RECEIVE AND FILE COMMUNICATION FROM THE PLAN AND ZONING COMMISSION REGARDING APPROVAL OF PRELIMINARY PLAT AMENDMENT TO THE "SOUTHWOODS ESTATES" PLAT FOR PROPERTY LOCATED AT 3800 SOUTHWEST 56TH STREET

Communication from the City Plan and Zoning Commission advising that at their meeting held February 7, 2019 the following action was taken regarding a request from TK Development, LLC (owner) represented by Dan Kruse (officer) for review and approval of a 2nd Amendment to the Preliminary Plat for "Southwoods Estates" on property located at 3800 Southwest 56th Street, to allow revision to the plat on the southern portion of the property to reconfigure the street layout and provide for a total of 63 single-family residential lots. The previously approved 1st Amendment to the Preliminary Plat provided for a total of 45 single-family residential lots with two outlots for future platting.

STAFF REPORT TO THE PLANNING COMMISSION

PRELIMINARY PLAT
2nd AMENDMENT
TO SOUTHWOODS
ESTATES
 Sheet 1 of 5

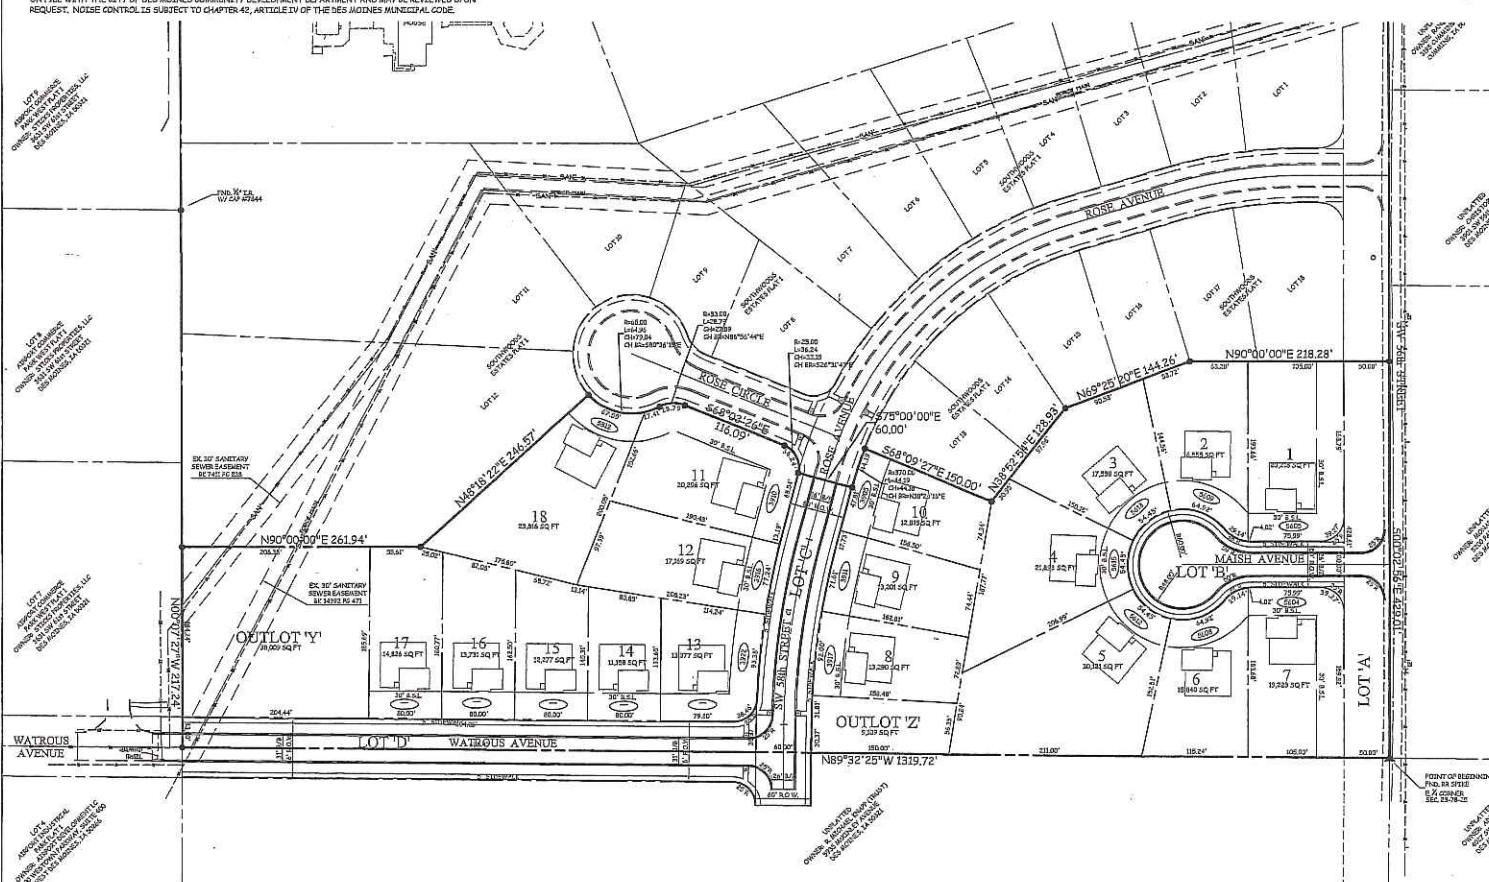
- 5. Traffic/Street System:** The resubmitted Preliminary Plat shows that the lots in the amendment area would be served by a system connecting Rose Avenue/Southwest 58th Street between Southwest 56th Street and an extension of Watrous Avenue. Rose Circle would be a cul-de-sac off of Rose Avenue to the west. Rose Avenue is proposed to dead-end into privately-owned property to the south. Maish Avenue would be a cul-de-sac running west of Southwest 56th Street. The developer has also proposed a Lot D for future extension of Watrous Avenue to Southwest 58th Street. This was based on a preferred alignment for the extension of Watrous Avenue in MoveDSM.

After meeting with Community Development Staff, Engineering Staff, Fire Department Staff, and the property owner to the south, it was determined that a viable solution would be for the current developer to plat the extension of the Watrous Avenue to the end of Rose Avenue/Southwest 58th Street. This would provide a through connection for traffic circulation and allow the developer of property adjoining to the south to plat the further extension of a through traffic movement from Watrous Avenue to Southwest 56th Street.

The developer is seeking to phase the public improvements with the proposed solution making the Watrous Avenue extension at a point in the future. In order to prevent indefinite deferral of these improvements, Staff recommend that any further Final Plat consideration provide the dedication of all remaining street Rights-Of-Way within the Preliminary Plat along with providing adequate surety or bonds for the installation of the portion of those improvements within the platted property. This would better facilitate the City completing the public improvements should the development stall for whatever reason.

Phasing the completion of the street improvements also presents challenges in meeting compliance with Fire Codes. Without through extension of the street network, homes built on dead-end street segments beyond 750 feet in length would require special approval of alternative design for fire protection by the Fire Chief. In previous developments this has involved solutions such as adding fire sprinkler systems to single-family dwellings. Any Preliminary Plat approval should require compliance with all Fire Codes for buildable lots.

APPROVAL of the submitted 2nd Amendment to the Southwoods Estates Preliminary Plat subject to the following conditions:

2. Any further submitted Final Plat pursuant to this Preliminary Plat amendment shall dedicate all remaining street Rights-of-Way within the Preliminary Plat.
3. The City shall be provided guarantee in a form approved by the City Engineer and City Legal Department, which may include an escrow agreement, surety or bonds, for the completion of all public improvements within the approved Preliminary Plat amendment as part of any further Final Plat phase of the development.
4. Development of any lots within any further Final Plat phase of development shall demonstrate compliance with the Fire Code.
5. Any further Final Plat phase shall provide necessary Avigation easements for platted lots as determined necessary by the Des Moines Airport Authority.

PRELIMINARY PLAT
2nd AMENDMENT
TO SOUTHWOODS
ESTATES
 Sheet 2 of 5

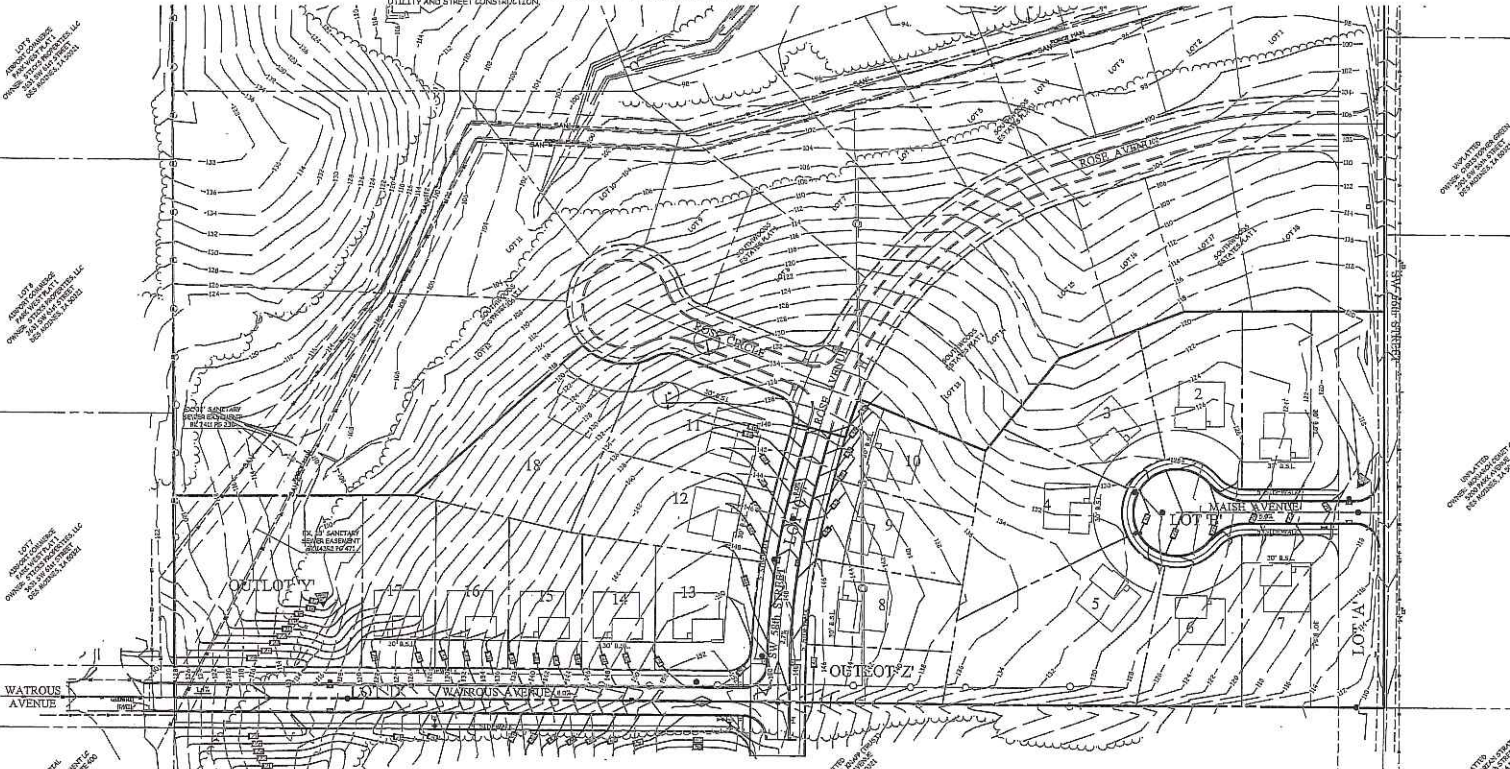
- 4. Drainage/Grading:** The proposed stormwater management solution involves providing a detention basin at the eastern end of the drainageway. There are 18-inch public storm sewers proposed in Rose Avenue, Rose Circle and Maish Avenue out letting to the proposed basin to the north and drainageway to the south. The developer is required to design both flood control detention and water quality detention into a development of this area. The applicant has provided revised drainage design details and calculations to comply with the storm water management requirements.
